ITEM 6.1: Rezone, Conditional Use Permit, and Design Review Permit – 1100 Orlando Av. – INFILL PCL 229 – Bee Shine Carwash – PL22-0316

REQUEST

Figure 2 – Project Noise Contours

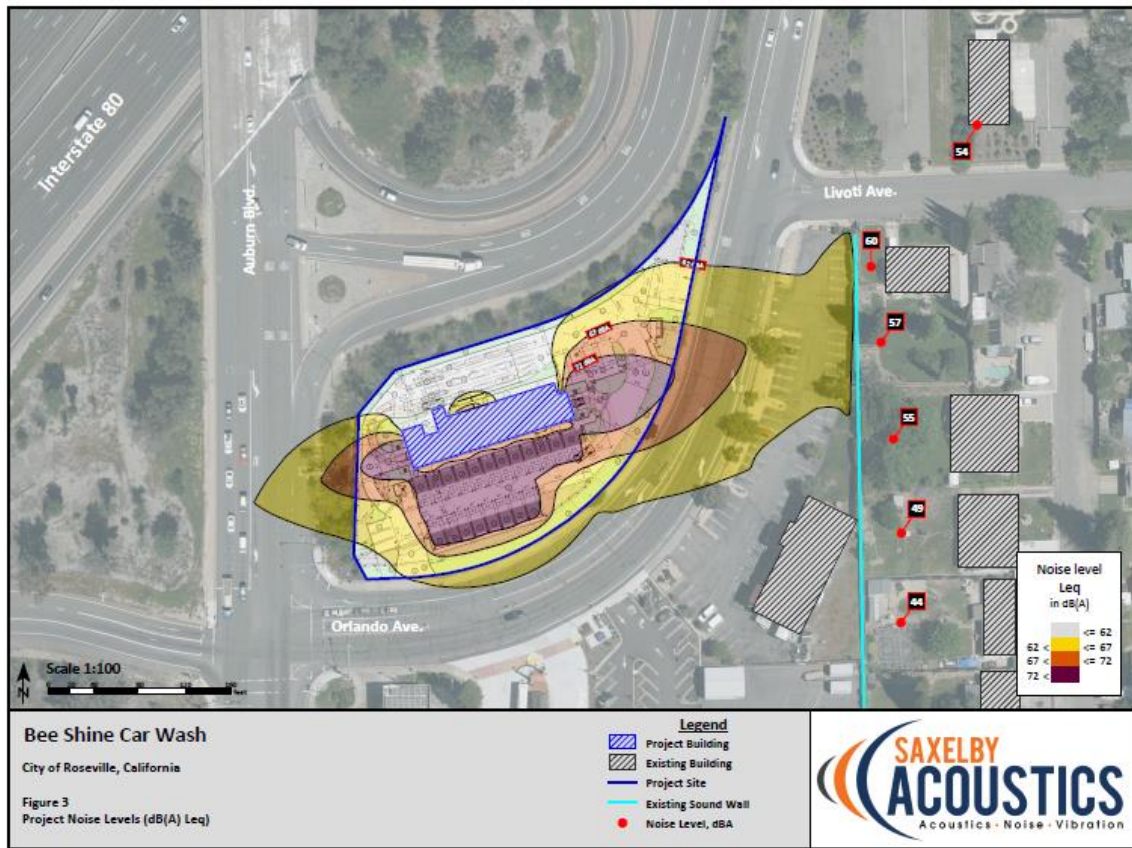
The study evaluated several noise-generating components of the project, including the carwash dryers, semi-central vacuum producer, rooftop HVAC, and parking lot. The data used in the study relied on manufacturer’s data, as well as Saxelby Acoustics data from similar carwash operations. A model (SoundPLAN noise prediction model) incorporated the sound power levels for the proposed carwash tunnel, existing and proposed buildings, terrain type, and locations of sensitive receptors, noise levels would not exceed 62 dBA Leq at the property line of the subject property. The study indicates that the most significant source of noise on the site would be vehicle circulation, rather than any mechanical equipment associated with the carwash use. Figure 2 of this report shows the project noise contours.

Due to the shape of the subject parcel, the carwash tunnel and vacuum stations are oriented towards the east and south. The exit for the tunnel, where the air dryers are located, are on the east side of the tunnel, oriented towards Orlando Av. and Livoti Av. The vacuum stations are to the south of the tunnel, closer to Orlando Av. The nearest home is located on the east side of Orlando Av., approximately 175 feet from the property line of the proposed project site. As the proposed project is not anticipated to exceed noise standards at the property line and only operate during daytime hours, no mitigation measures are recommended; however, the project includes a CUP, which will include a condition of approval to limit operations to daylight hours (CUP Condition #2). At the time of staff report publication, no comments or concerns were received by staff regarding the proposed project. No impacts to health, safety, or welfare of persons working or residing in the area are anticipated as a result of the proposed project.

Figure 3: Carwash Tunnel South Elevation

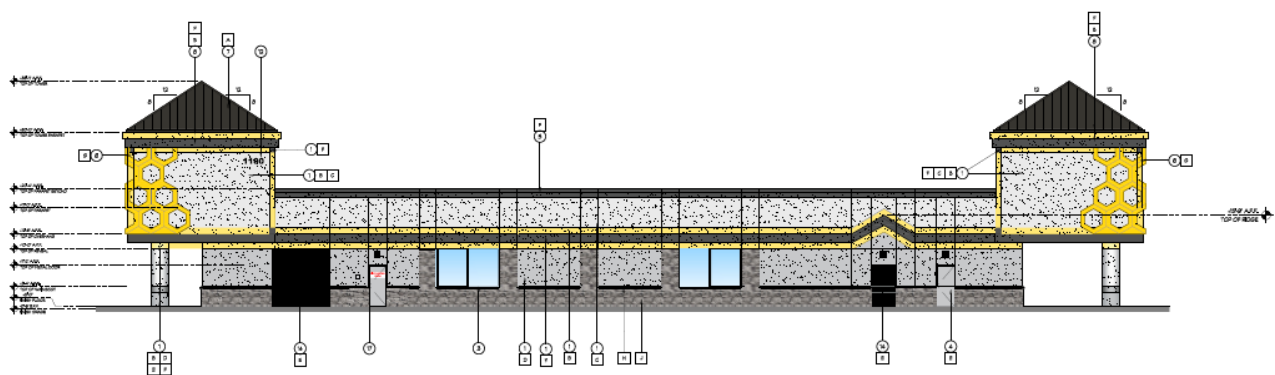
The proposed building includes variations in the rooflines, architectural treatments, colors, and materials, as recommended by the Community Design Guidelines (CDG). The carwash tunnel building incorporates a variety of materials, including stucco, stacked stone, metal accents, and a standing seam metal roof. The colors include grey tones for the stucco and stone, with a yellow as an accent color throughout. The tunnel opening is accented with a tower feature and the honeycomb detail to represent the business brand. The site also includes a knee wall to shield the vacuum area, which uses the same stacked stone as the main building. The colors, variety of materials, and overall design are consistent with the Community Design Guidelines.
